# Design Review Board Agenda

**CITY OF MILL CREEK  
DESIGN REVIEW BOARD  
APPLICATION PL2019-0008**

**NAME OF PROJECT:** Clock Tower Phase II – Mini Storage Facility

**PROPOSAL:** Review of building elevations and materials

Sheet  
**A2.0**

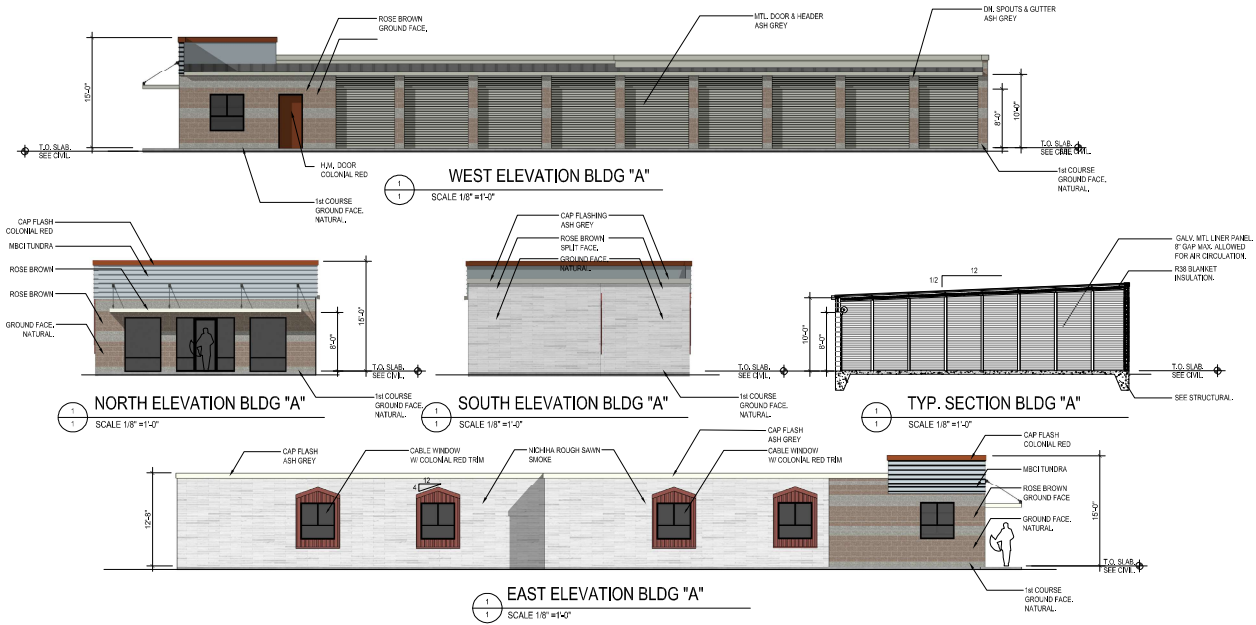
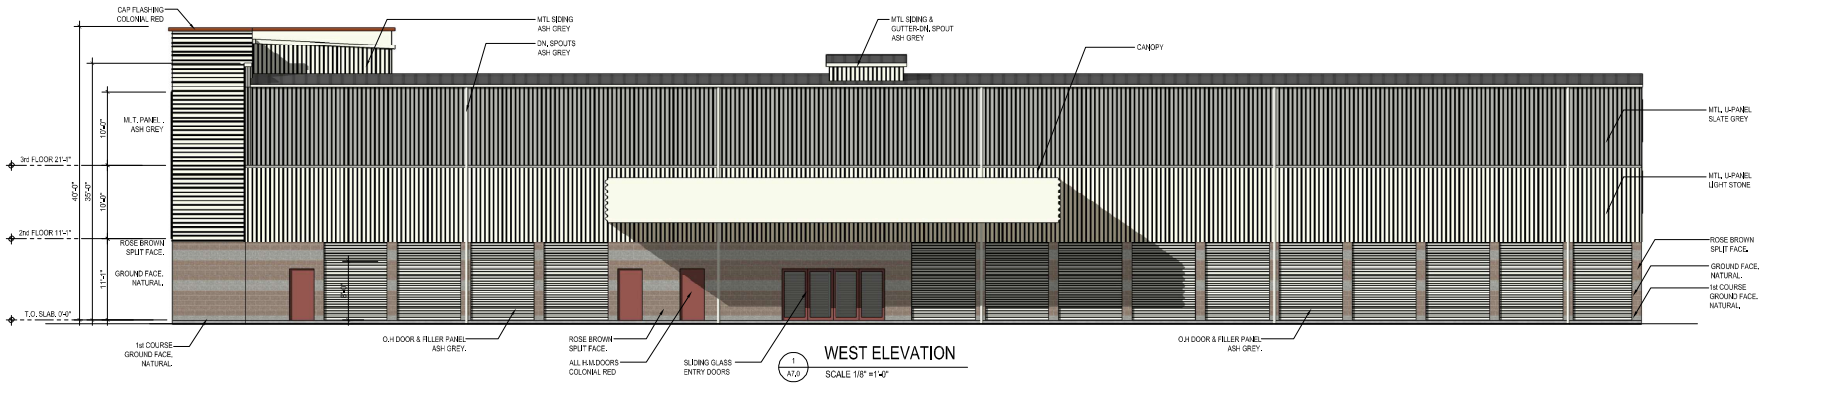
have windows trimmed colonial red metal with an architectural peak to break up the wall expanse. Access to the storage units are on the western façade with one door (no awning proposed) and a window. The northern façade will have windows with an awning to create a storefront appearance at the driveway entry with a faux parapet. On the south elevation, the applicant is proposing to break up the expanse by using three different colors and two different materials. See **Attachment 4 – Building A Elevations**.

- Building A on the western façade install an awning over the access door.
- Building B shall include canopies on the eastern and western facades as shown on Attachment 5.

1. The building elevations, materials, colors, and design shall be as portrayed in the application and the following revisions:
  - a) Building A on the western façade an awning shall be installed over the access door.
  - b) Building B shall include the canopies as shown on the eastern and western facades on Attachment 5.
2. If a trash enclosure is installed the design shall be consistent with MCMC 17.34.040.8 and a building permit shall be submitted and approved prior to installation.
3. A building permit is required to be submitted and obtained for the proposed black metal fencing and gates prior to installation.

**A7.2**

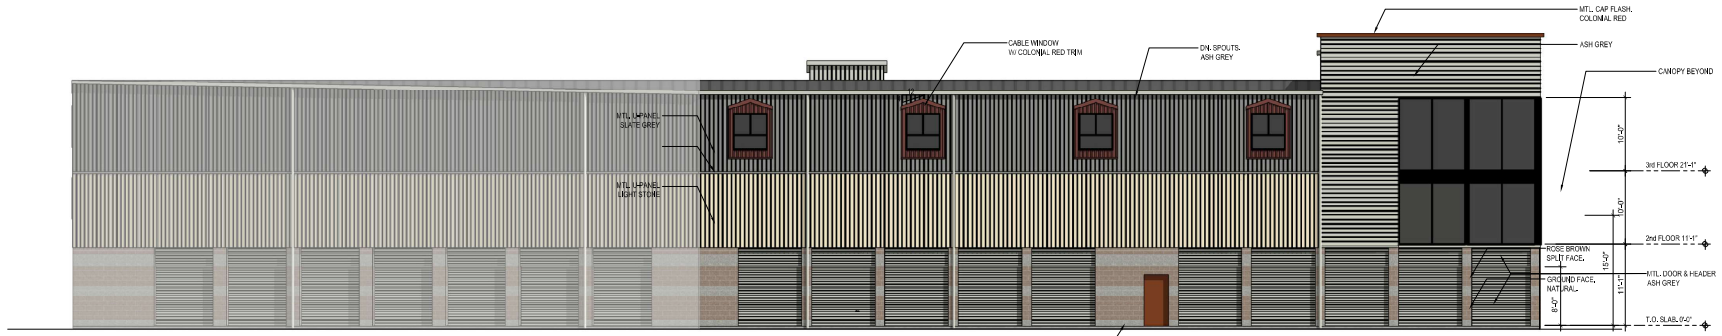
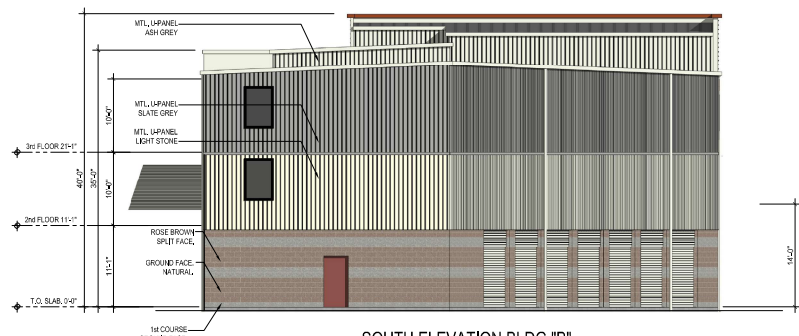
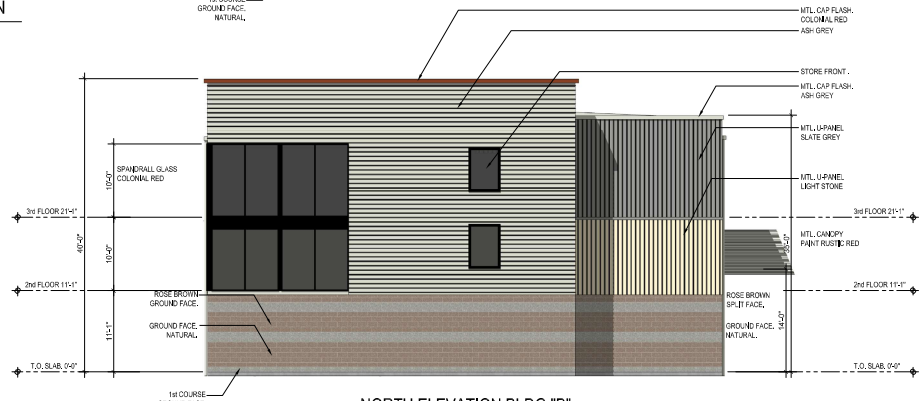
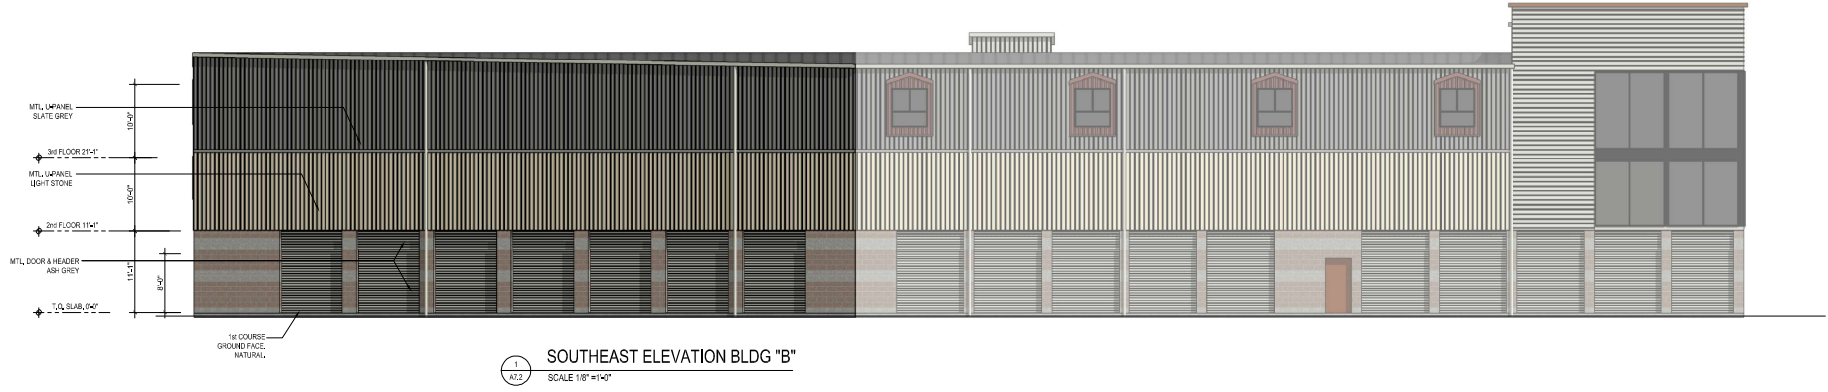
Building B is located in the center of the site and is proposed to be 39 feet in height with an elevator. On the northern façade, a large window will create a focal point and occupy the second and third floors and allow visibility into the building, see **Attachment 5 – Building B Elevations**. Canopies are shown on both the east and western facades on **Attachment 5**, but are not shown on **Attachment 2**. The canopy on the western side of Building B extends to the roofline of Building C to serve as a covered load and unloading area. Staff recommends use of the canopies to be consistent with City's Design Standards. The eastern façade has windows in the center portion of the building to provide visual interest and to match Building A.
